Application No.: 10/582,096
Art Unit: 3633

Amendment under 37 CFR §1.111
Attorney Docket No.: 062626

AMENDMENTS TO THE DRAWINGS

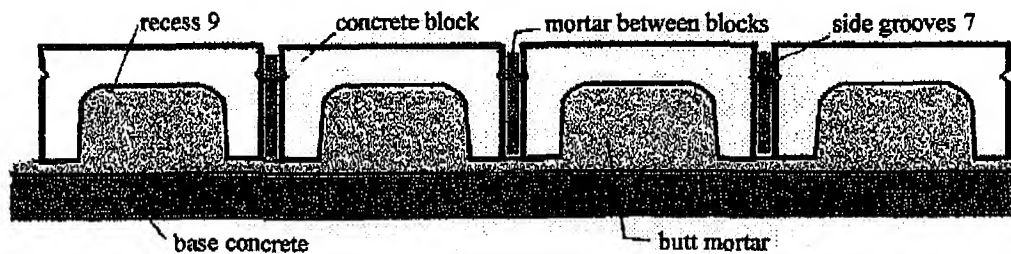
In addition to the above features, there is another which is a collaborative relationship between the features of claim 1 of the present application of “a recess in the rear surface for reducing the weight of the block” (item 9 in FIGS. 1D, 1F and 1G) and “displacement prevention grooves in respective side surfaces of the block”, wherein it comes into effect after completion of mortar works in the staircase construction. This collaborative relationship may be easily understood from the apparent aforementioned features by those who are skilled in the art.

The recess 9 behind the block is filled-up with butt mortar, and the block is fixed in its horizontal location on the base concrete. This makes the blocks hard to move horizontally, and the side surfaces of the blocks, where the displacement prevention grooves 7 are engraved, are prevented from being separated, as illustrated in the figure below.

Thus, separation of the side surfaces of the blocks due to external shock such as earth quakes is effectively avoided, and displacement prevention, effects of the grooves 7 are steadily kept. This collaborative relationship between features is not taught by any of the cited references.
